SUNDRY NOTICES AND REPORTS ON WELLS

# RINCON UNIT Well No. 19

Attachment to Notice of  
Intention to Abandon

Re: Permanent Abandonment

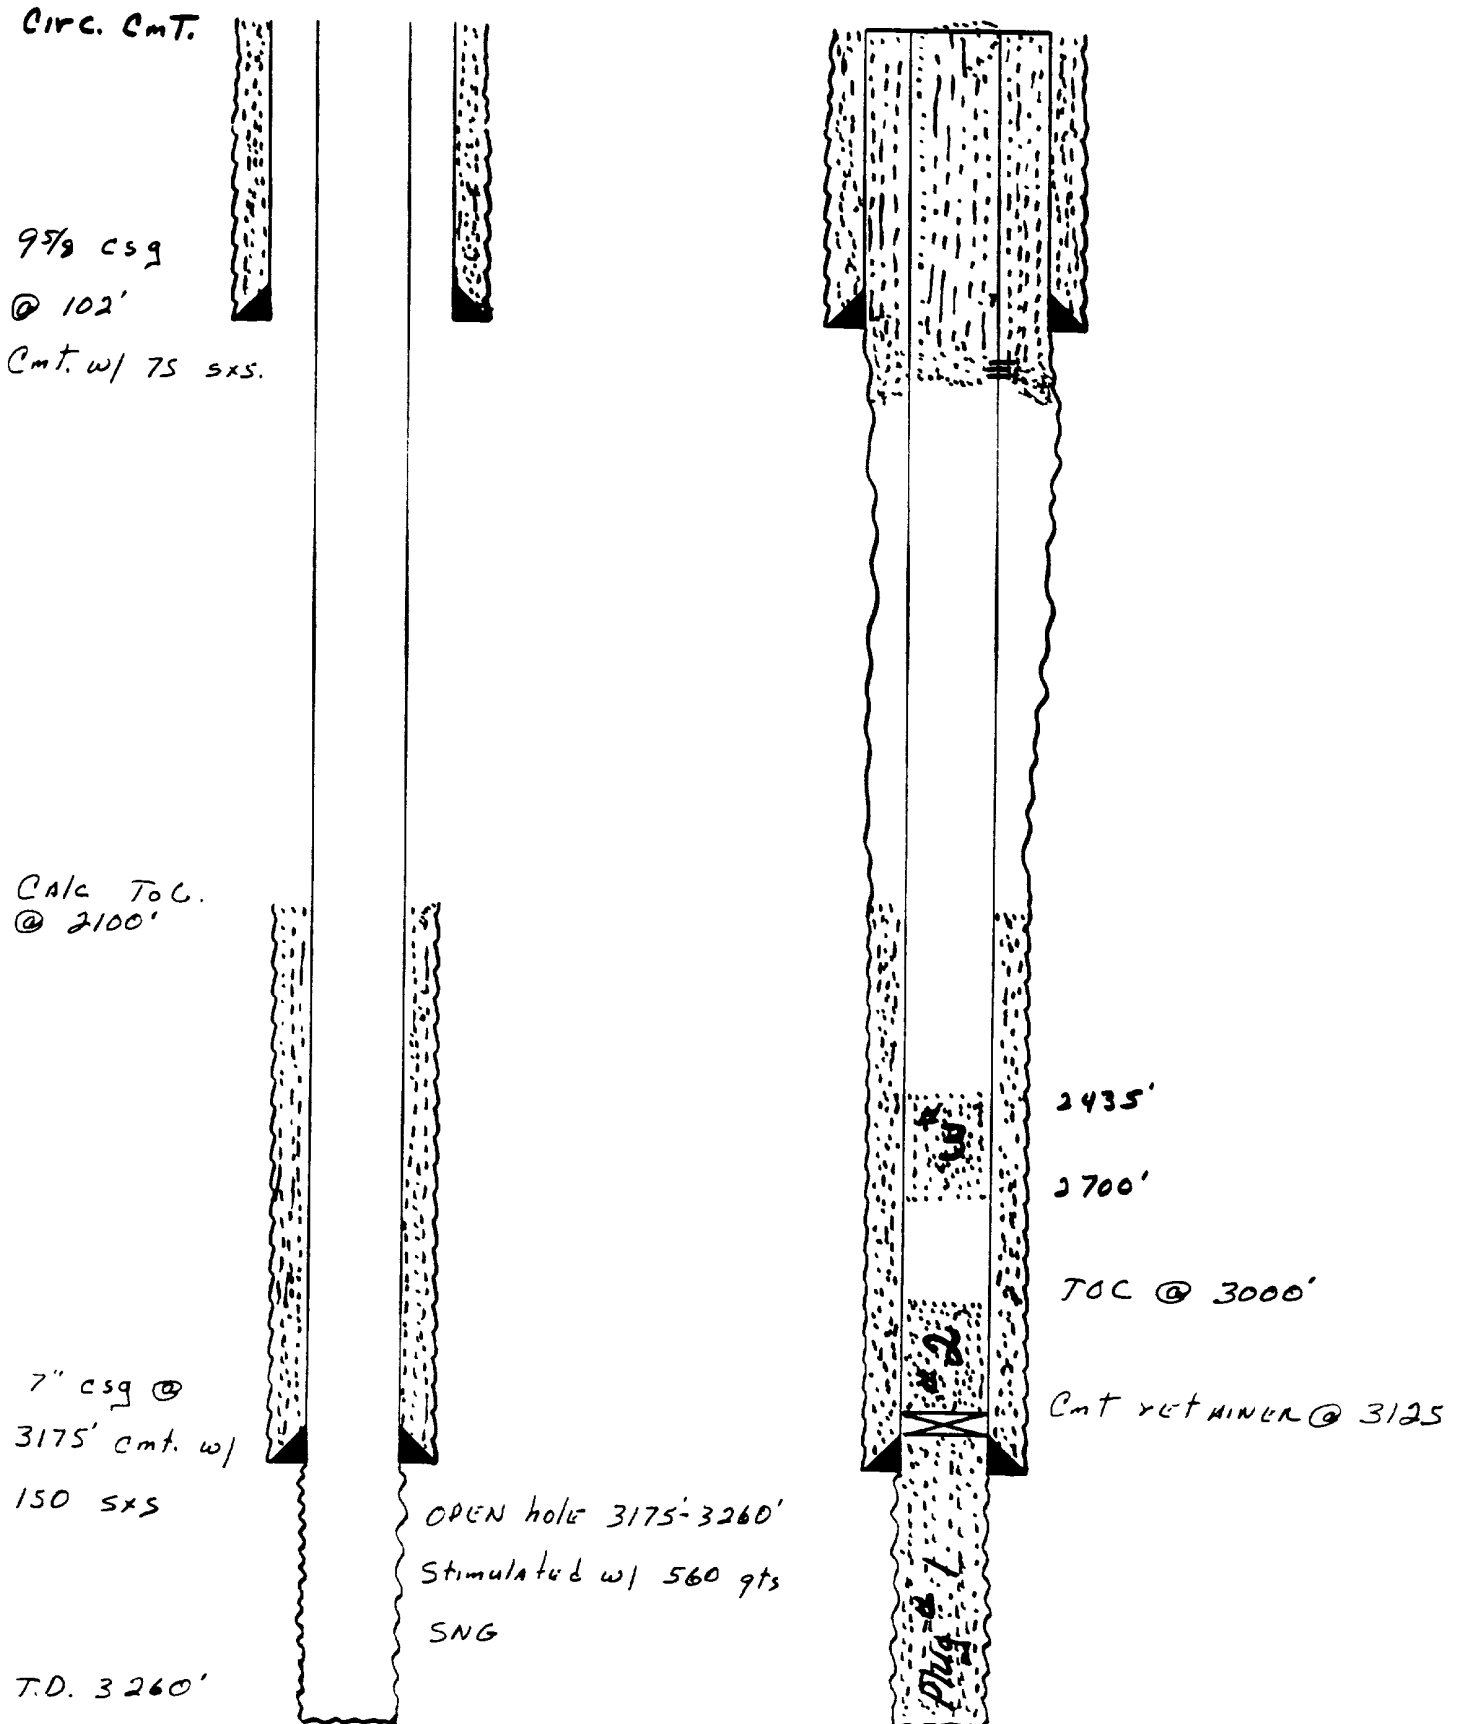
4. The following modifications to your plugging program are to be made (when applicable):

*Add a plug from 1300-1200 inside & outside 7" casing 66 SX*
